**WSD5 – Check Coolant Expansion Tank Cap and Replace if necessary (Workshop Campaign)**

Model Line: **911 (992)**

Model Year: **As of 2024 up to 2026**

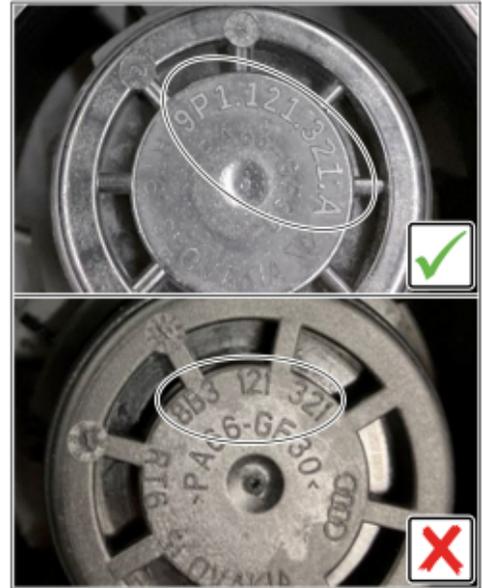
Cause: **A cap on the coolant expansion tank with incorrect pressure compensation valve was potentially installed on the affected vehicles.**

If this is the case, coolant loss cannot be ruled out upon increased pressure in the cooling system.

Assessment		Action
(✓)	The <b>part number "9P1.121.321.A"</b> is applied to the coolant expansion tank cap.	Coolant expansion tank cap is <b>ok</b> . Then continue with Step 3. [Warranty processing: Scope 1]
(✗)	The <b>part number "8B3 121 321"</b> is applied to the coolant expansion tank cap.	Coolant expansion tank cap is <b>not OK</b> . <b>Replace coolant expansion tank cap.</b> Then continue with Step 3. [Warranty processing: Scope 2]

Action: Check cap on the coolant expansion tank and replace if necessary.

Part No.	Designation	Quantity
9P1121321A	⇒ Cap on expansion tank	1 piece
